Diamond
AIRCRAFT

Service Bulletin No.: DA20-24-03, Rev. 0

Title: Electrical Cables, Engine Compartment

Figure 1.

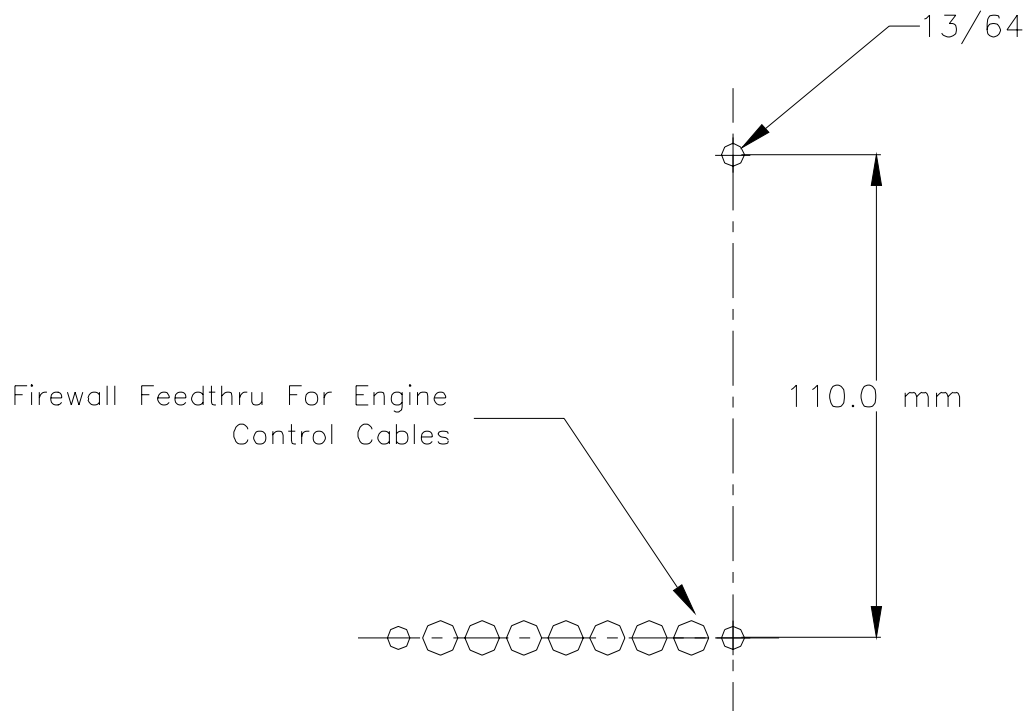
- 10.1 Remove the cowling.
- 10.2 Inspect the starter to see if the electrical stud for the power connection is pointing inboard or outboard. For aircraft with the electrical stud pointing inboard order material kit P/N DA20-24-03AMK0 (180mm starter cable). For aircraft with the electrical stud pointing outboard order material kit P/N DA20-24-03BMK0 (110mm starter cable).
- 10.3 Remove the old starter lead wire # 80103A4 and install the new wire cable assembly labelled #80103A4.
- 10.4 Disconnect the engine ground wire #24320A4N from the electrical shelf at one end and the #3 engine cylinder head at the other end. Remove the spiral wrap protective covering to allow removal of the wire from the harness.
- 10.5 Following the same routing install the new cable, wire #24320A4N. Reinstall the spiral wrap removed in 10.4.

Figure 2.

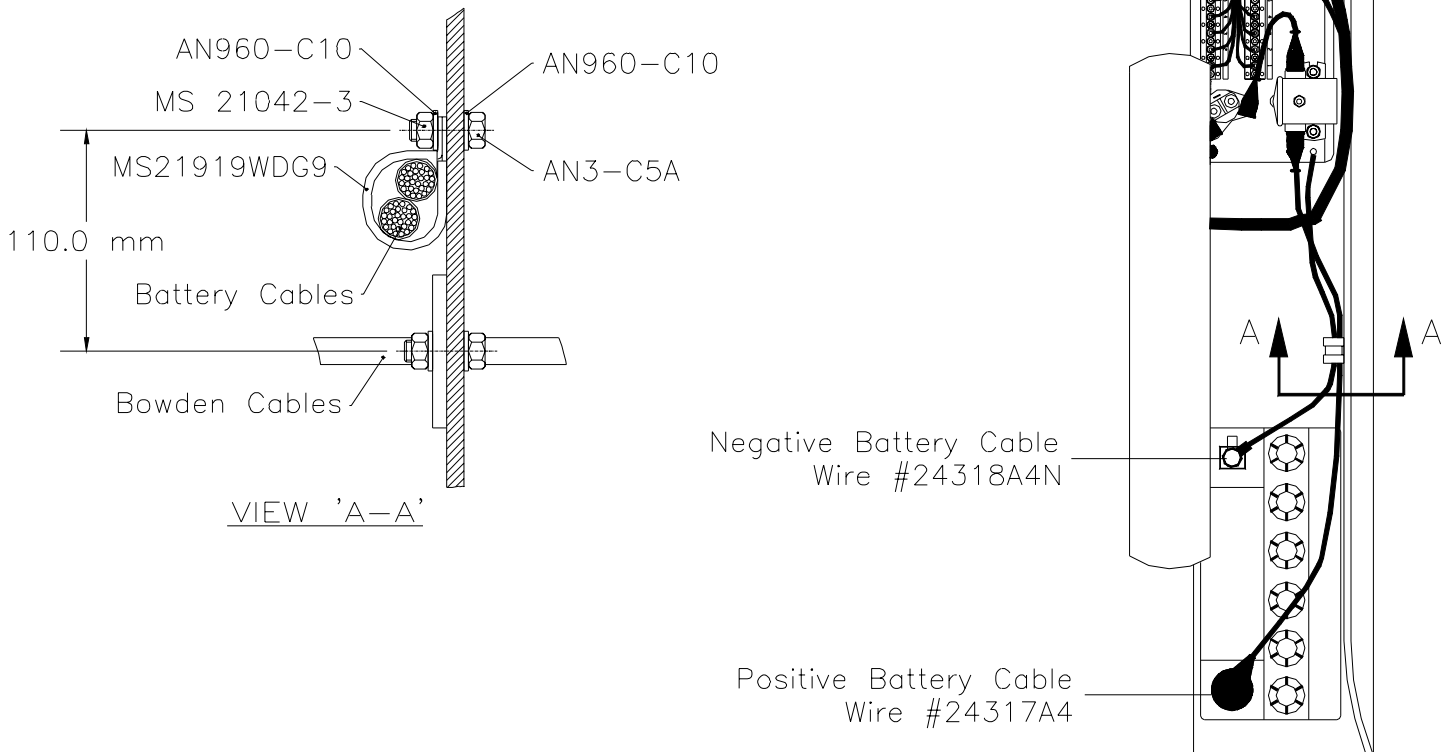
- 10.6 Disconnect the battery wires from the battery (negative lead first). Remove the battery from the battery box.
- 10.7 Remove the clamp holding the battery wires to the air box. Discard the clamp and mounting hardware.
- 10.8 Drill a 13/64 hole in the fire wall in the location shown in figure 1.
- 10.9 Put the wires into the clamp and install the clamp as shown in figure 2 for Rotax 912 F3 installations, or figure 3 for Rotax 912 A3 installations.
- 10.10 Reinstall the battery. Reconnect the battery cables making sure that the polarity of the connection is correct.
- 10.11 Check the operation of the battery, starter, and generator.
- 10.12 Reinstall the cowlings.
- 10.13 Make a log book entry in the aircraft technical log.

FIGURE 3

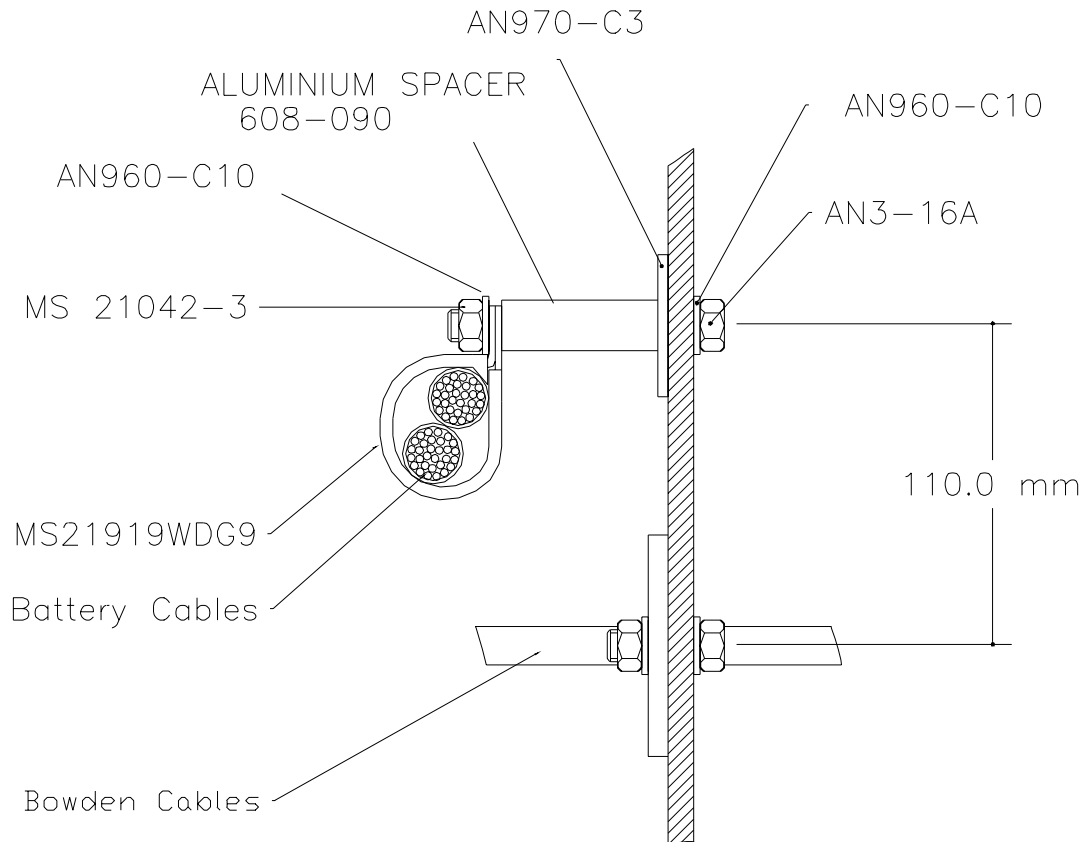
Use Spacer When Rotax 912 A3 Engine Installed
